Ketchum / SVWSD Water Reclamation Facility  
Aeration Upgrades

**ADDENDUM NO. 3**

February 21, 2024

1 AERATION BASINS NO.3 AND NO.4 OVERALL EXISTING DIFFUSER PLAN  
1/8" = 1'-0"

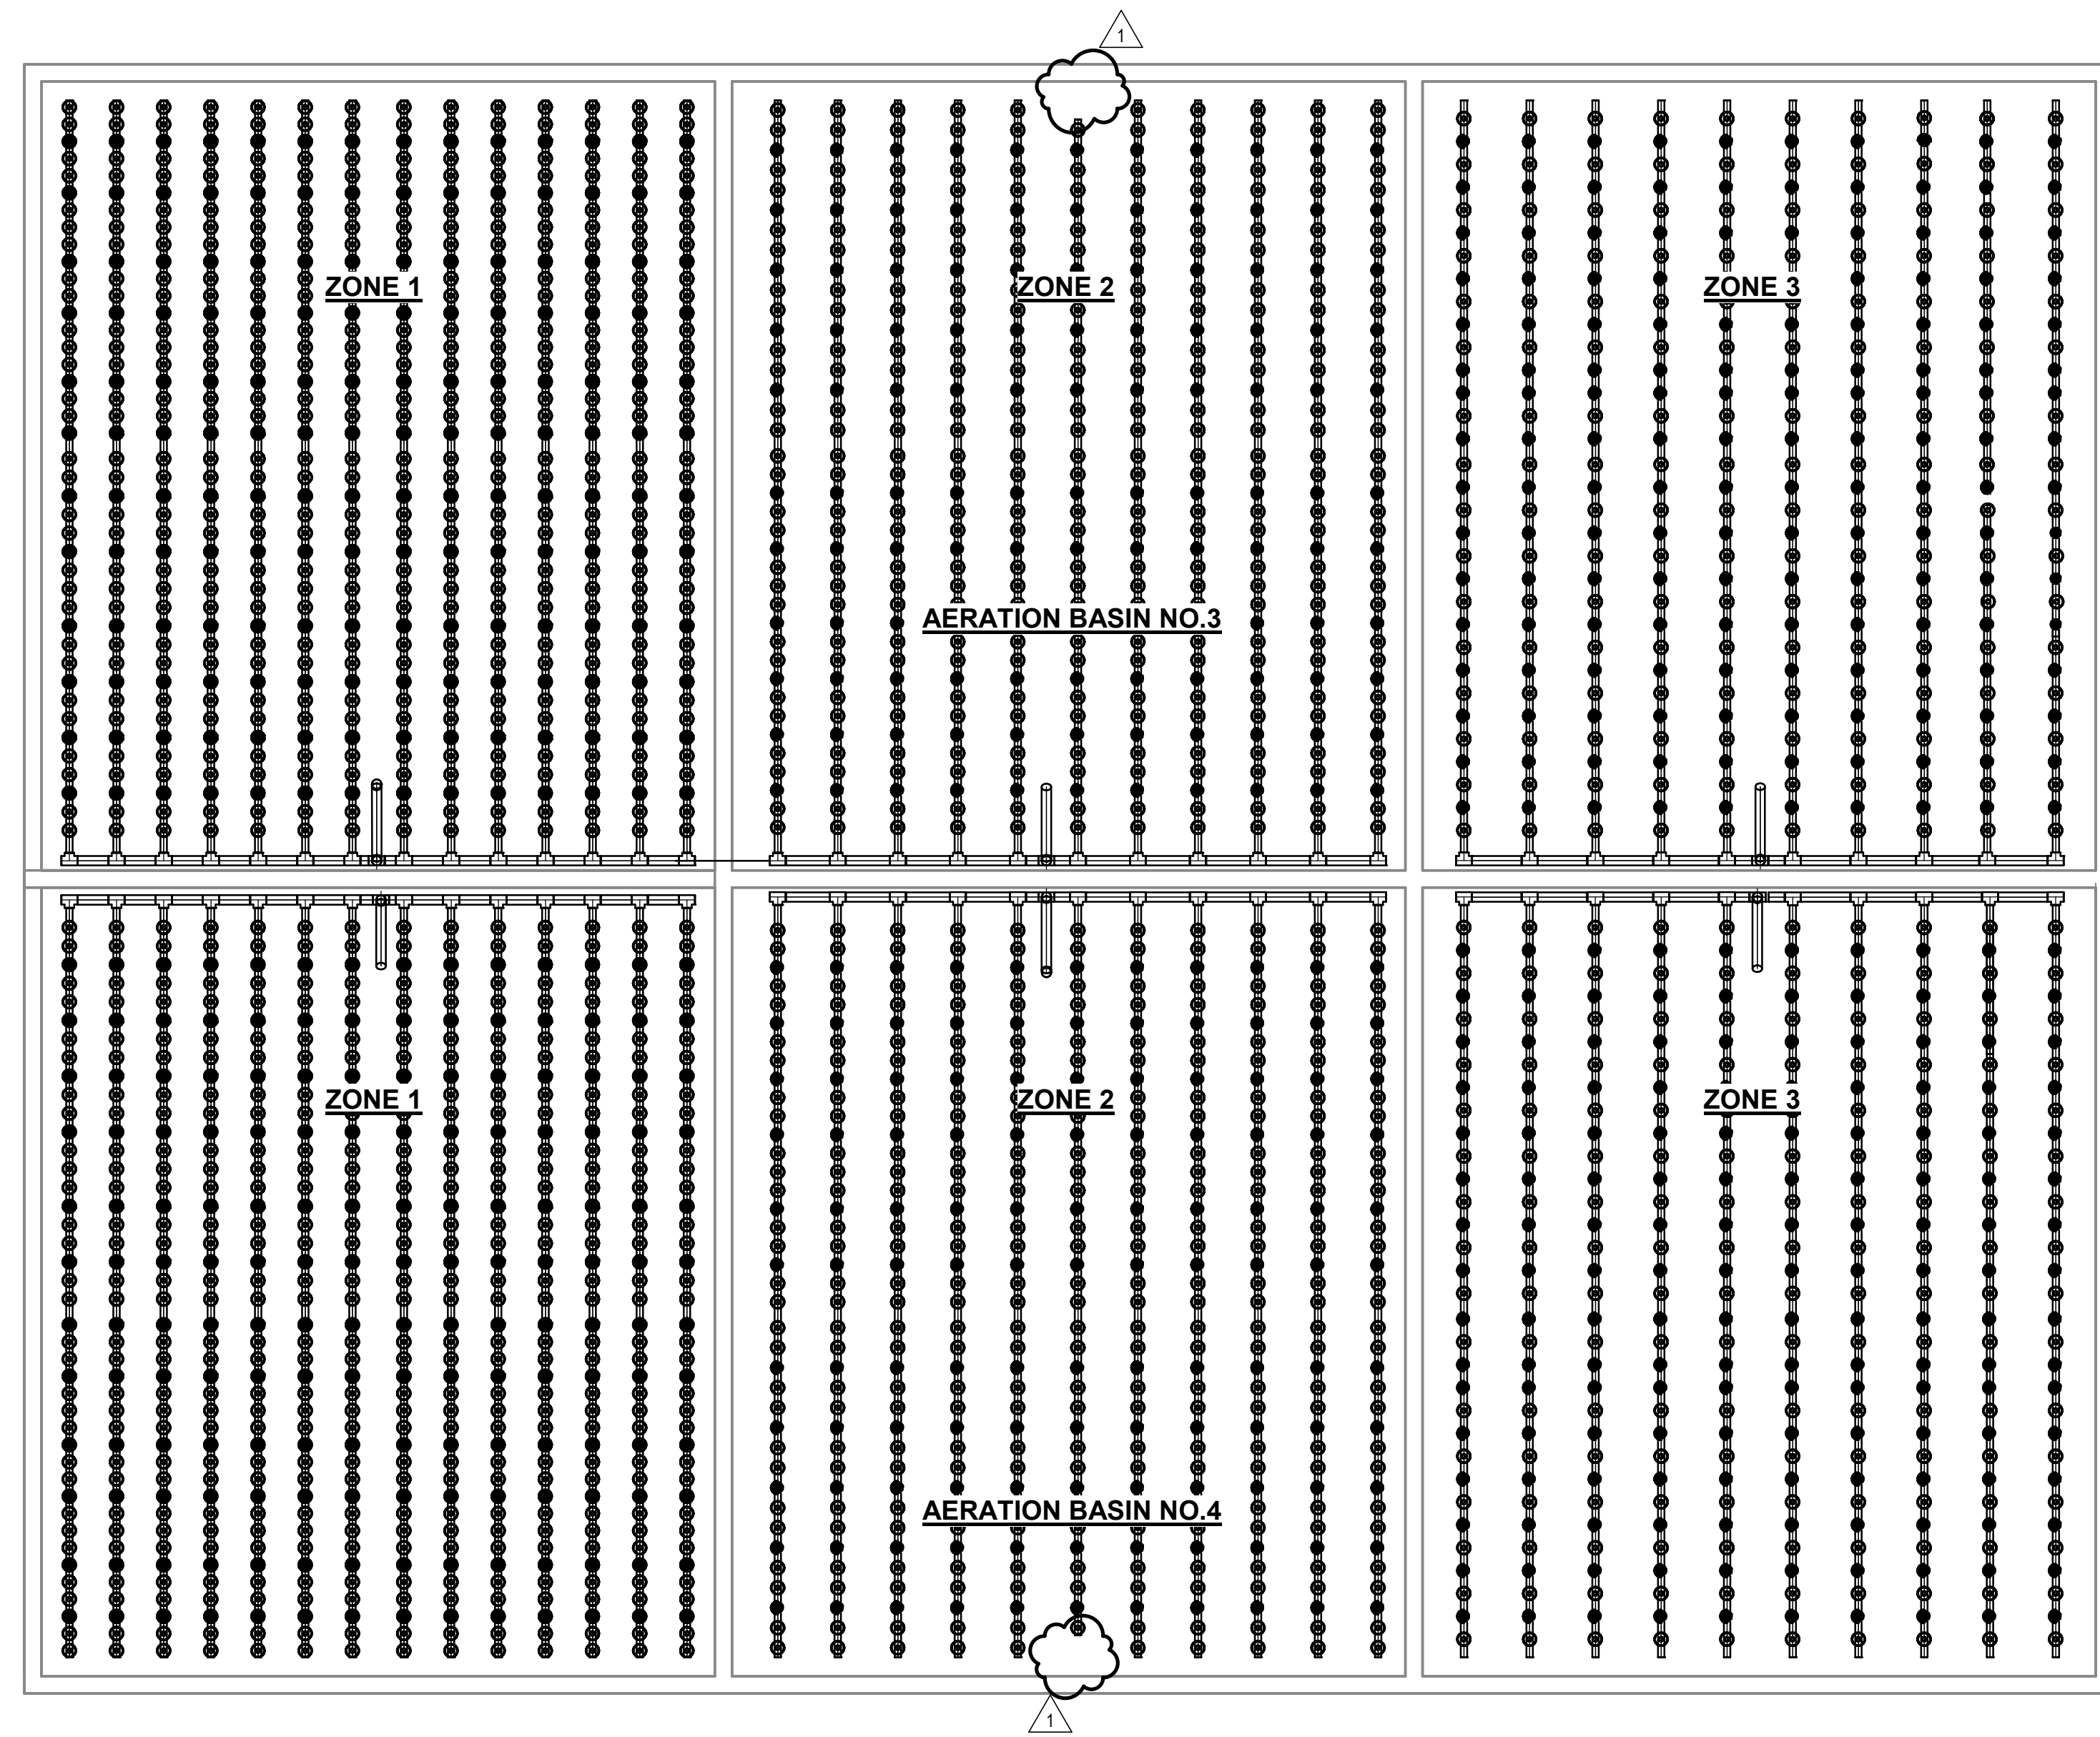
3.07 Drawing D-104: Process - Aeration Basins No. 3 and 4 Overall Diffuser Plan: Modify the Drawings as shown by Addendum No. 3 revision (removed one diffuser per Zone 2 in accordance with diffuser shop drawings).

**PROCESS  
AERATION BASIN ZONE 2 PLANS**

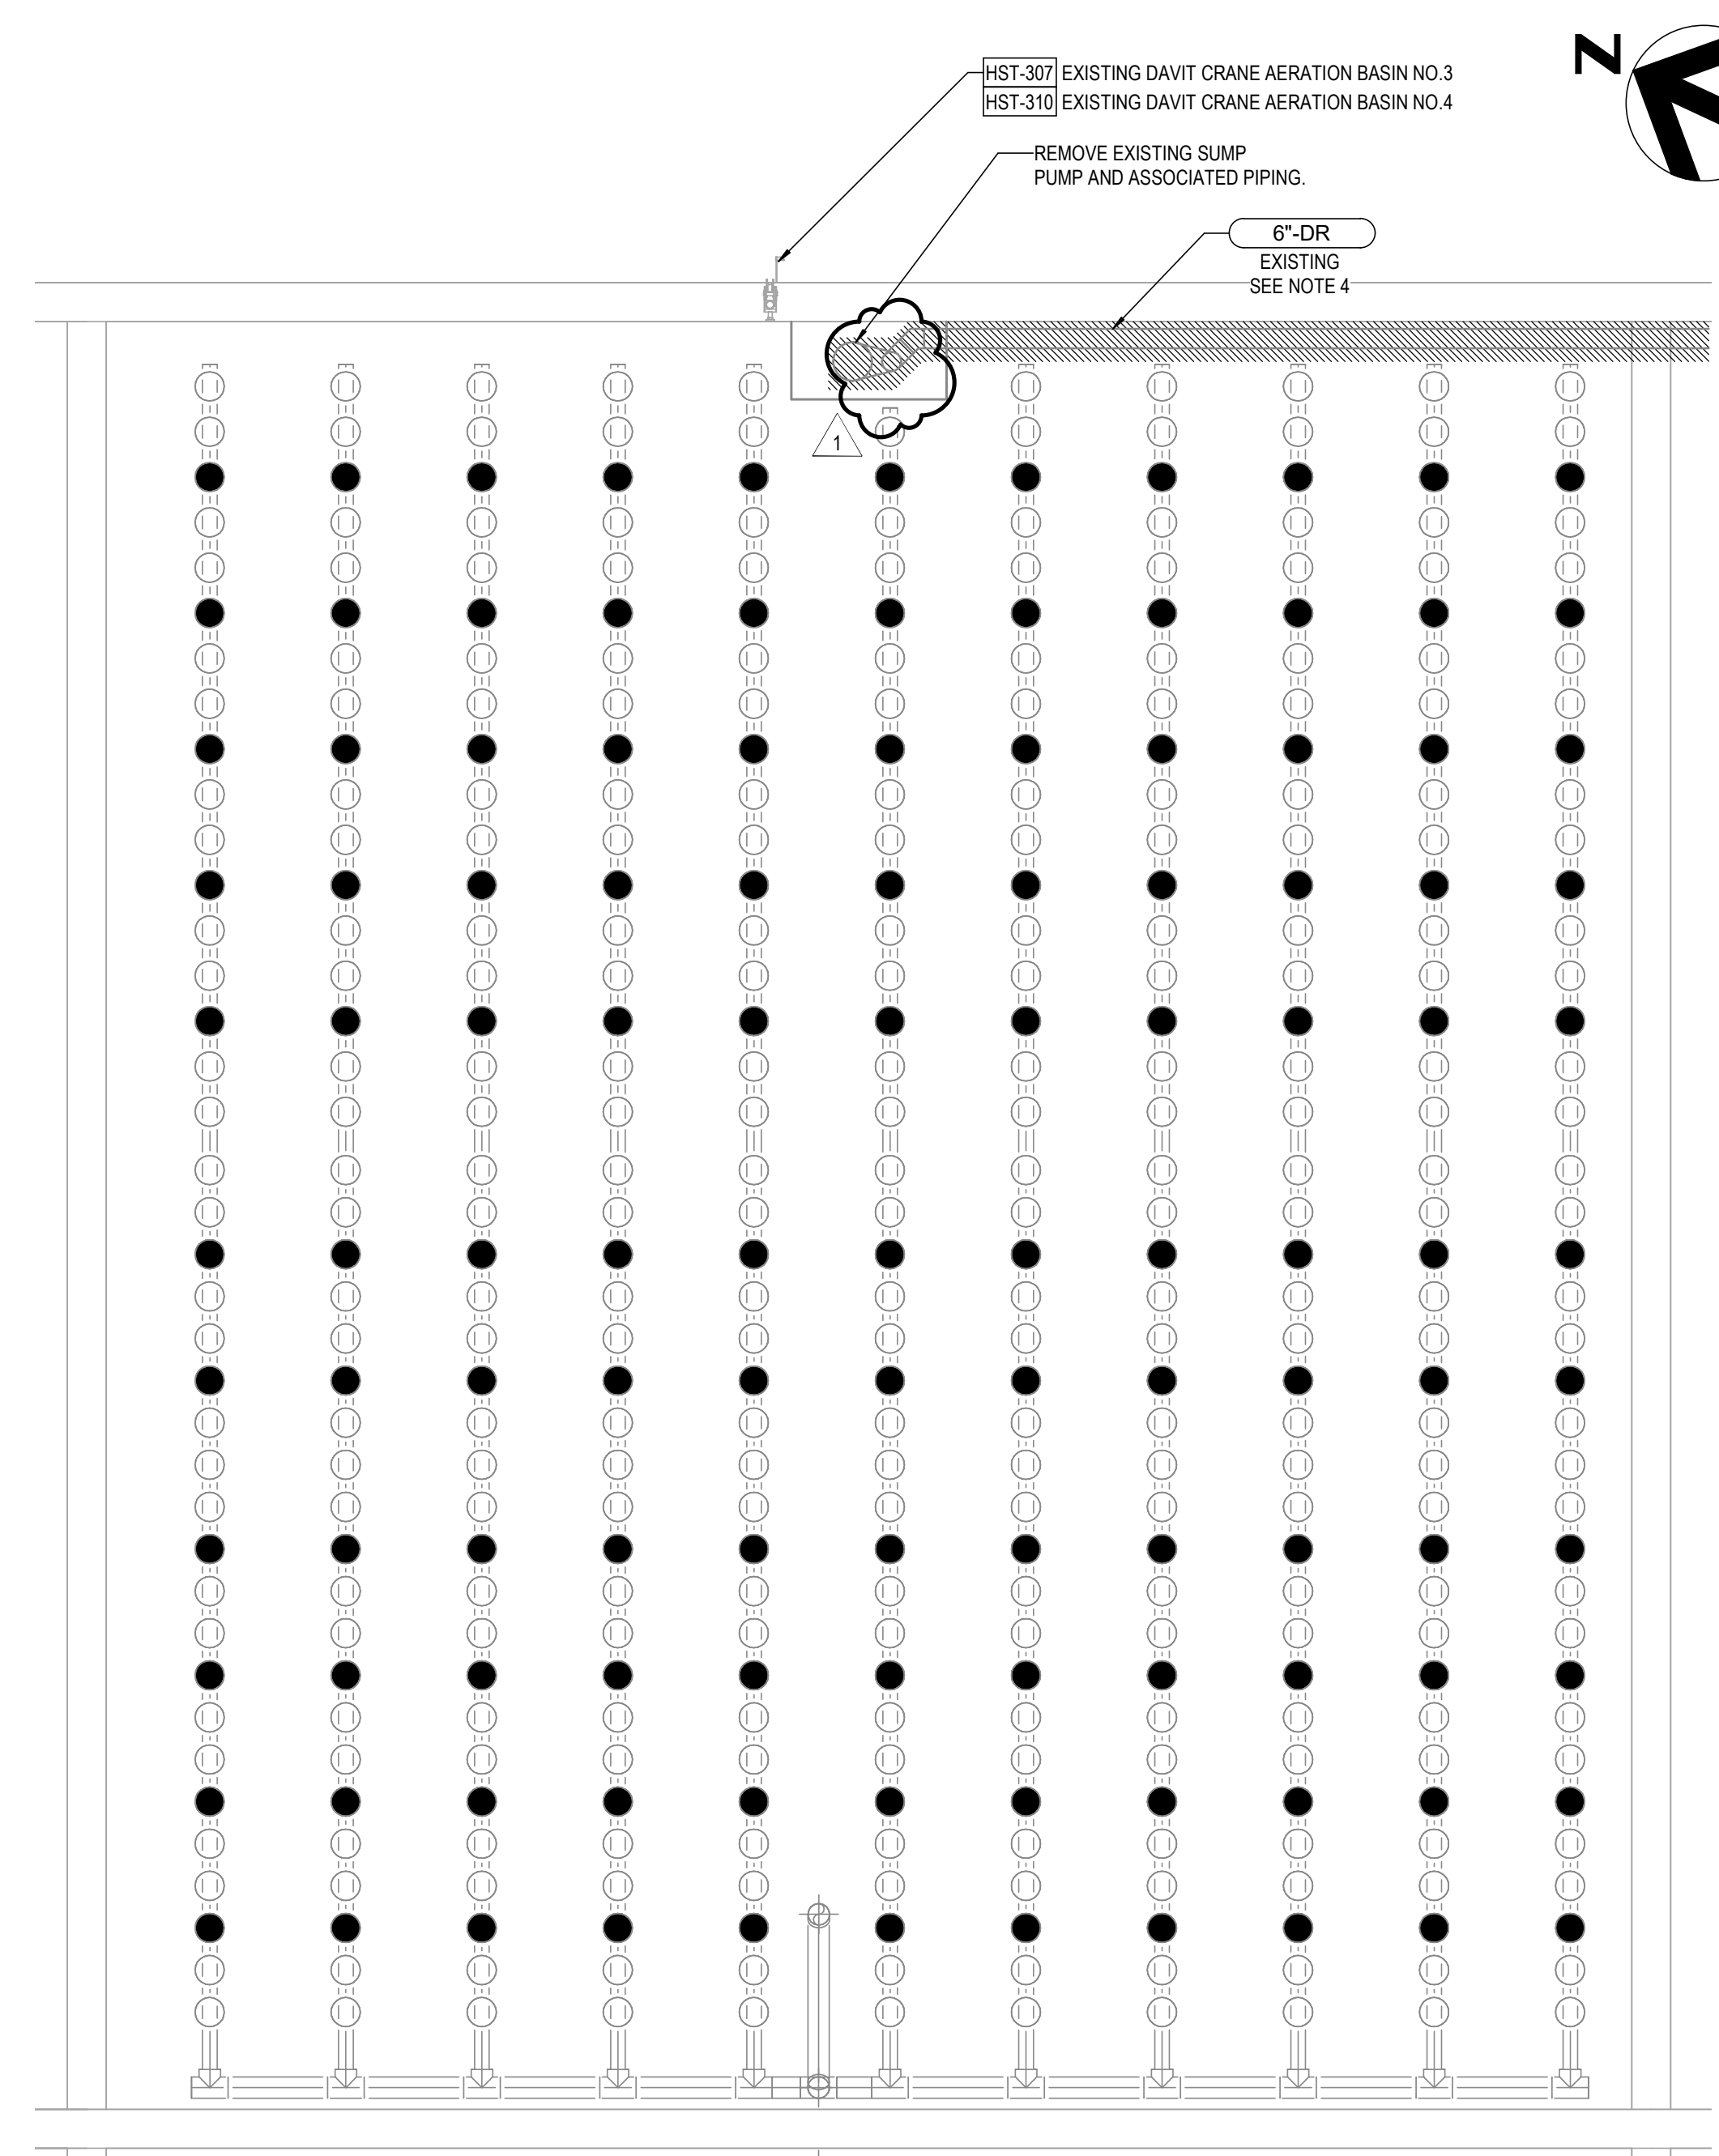
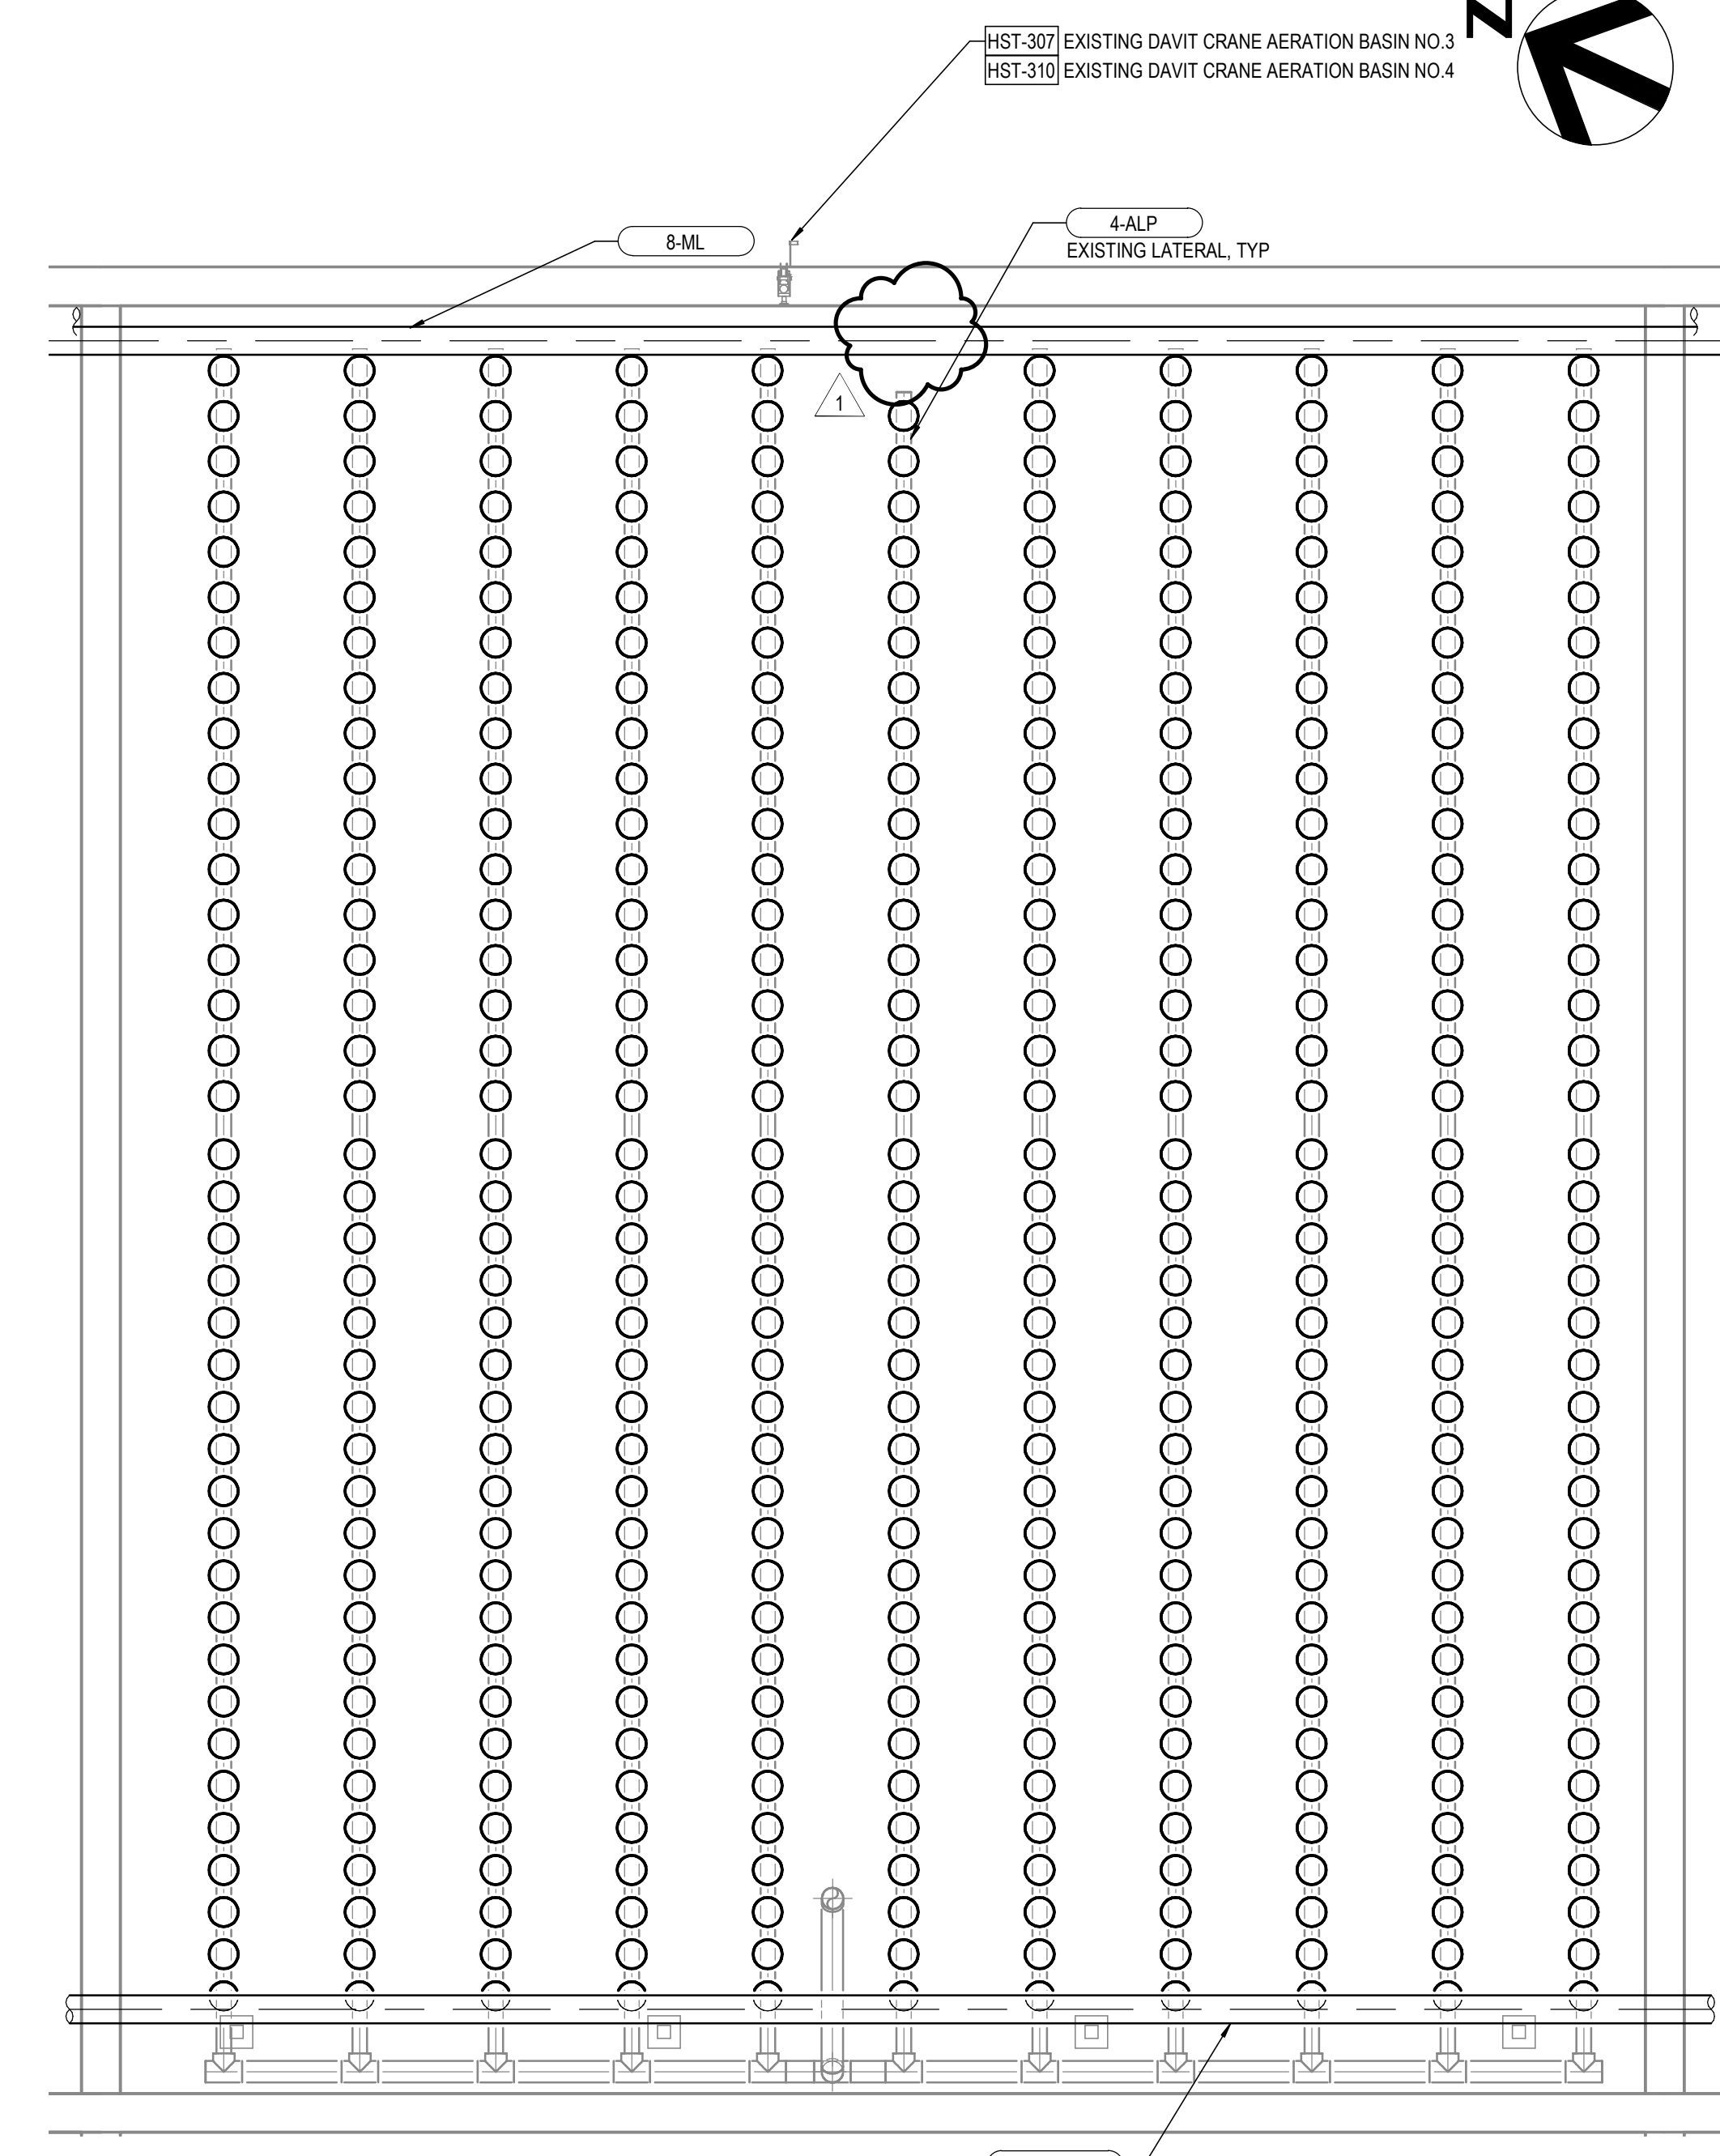
3.08 Drawing D-106: Process - Aeration Basin Zone 2 Plans: Modify the Drawings as shown by Addendum No. 3 revision (removed one diffuser per Zone 2 in accordance with diffuser shop drawings).
